# **A66 Northern Trans-Pennine project**

**TR010062**

## **7.8 Applicant's Response to Written Representations made by other Interested Parties at Deadline 1**

**Deadline 2**

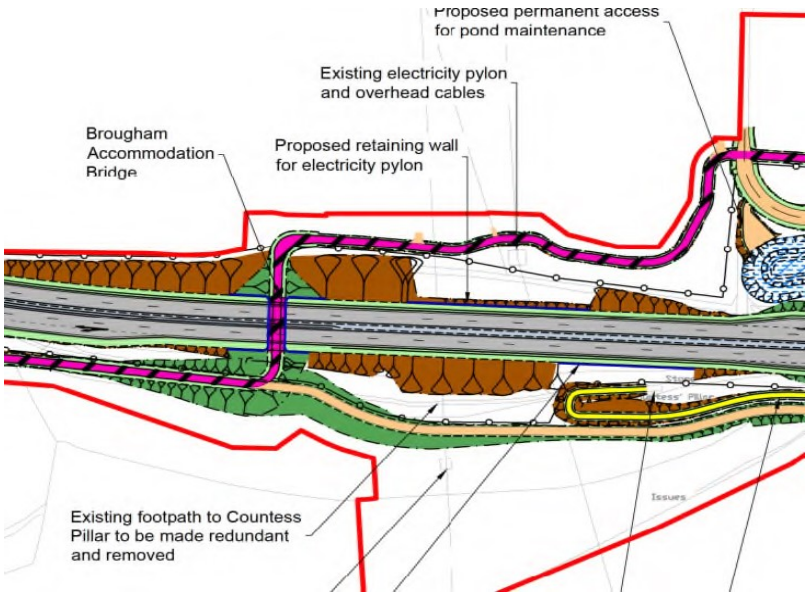
Examination Library Reference	Interested Party	Response Topic(s)	Written Representation (Verbatim)	National Highways Response
				<p>deliver. In addition, the CFTP at Table 6-18 describes the economic, transport, community and environmental benefits associated with the Cross Lane to Rokeby scheme. There is no evidence that the economic, transport, community and environmental benefits associated with the Cross Lane to Rokeby scheme, as set out in Table 6-19 would be any greater for the blue route, compared to the black route.</p>
REP1-010	Barnard Castle Town Council	Agriculture and soils	<p>Chapter 9: Economic See <a href="https://www.planninginspectorate.gov.uk/tr010062-001176-Barnard-Castle-Town-Council-Local-Impact-Reports.pdf">TR010062-001176-Barnard Castle Town Council - Local Impact Reports.pdf (planninginspectorate.gov.uk)</a></p>	<p>National Highways does not agree with the Town Council's conclusions set out in bullet points at the front of chapter 9 of their representation that:</p> <ol style="list-style-type: none"> <li>1. an increase in traffic along the B6277/A67 route will have a depressive effect on the local economy via congestion and pollution.</li> <li>2. that increased congestion and pollution will have a depressive effect on local house prices.</li> <li>4. that given congestion is likely to increase owing to the selection of the Black route, selecting the Blue junction at Rokeby will be more in line with planning policy and offer significant benefit to the town and its environs.</li> </ol> <p>We agree with the statement set out in the 3<sup>rd</sup> bullet point "that national and local planning aims to support local economies, especially NPPF 6 (strong, competitive economy) and 7 (the vitality of town centres)" but we do not consider that the Project conflicts with these policy objectives in any way and in fact the Project as well as the Cross Lane to Rokeby Scheme will help in achieving many of the economic and town centre objectives of the NPPF and similar policy objectives that are set out in the NNNPS. We address each of the four bullet points in turn, with reference to section 6.7 of the Case for the Project (Document Reference 2.2, APP-008), which sets out the Case for the Cross Lanes to Rokeby Scheme:</p> <ol style="list-style-type: none"> <li>1. There is no evidence that any increase in traffic along the B6277/A67 route will have a depressive effect on the local economy via congestion and pollution. Table 6-19 of the Case for the Project, which reviews the Cross Lanes to Rokeby Scheme against the Project objectives identifies that in addition to improving the strategic route network, the Scheme also makes improvements to the local road network, with new junctions and 'offline' improvements, removing local traffic from the A66, making local movements more efficient.</li> <li>2. There is no evidence that there will be increased congestion and increased pollution, which will have a depressive effect on local house prices. Table 6-19 of the Case for the Project, which reviews the Cross Lanes to Rokeby Scheme against the Project objectives identifies that reduced congestion and fewer vehicles idling will reduce emissions, helping to improve localised air quality. Further details on the environmental benefits of the scheme are outlined within the ES (Document Reference 3.2, APP-044 to 3.4, APP-233).</li> <li>3. As set out above there is no evidence that the Scheme and Project would conflict with the policy objectives 6 and 7 of the NPPF and in fact the Project as well as the Cross Lane to Rokeby Scheme will help in achieving many of the economic and town centre objectives, given the findings set out in Table 6-19 of the Case for the Project.</li> <li>4. There is no evidence that the economic, transport, community and environmental benefits associated with the Cross Lane to Rokeby scheme, as set out in Table 6-19 would be any greater for the blue route, compared to the black route.</li> </ol>
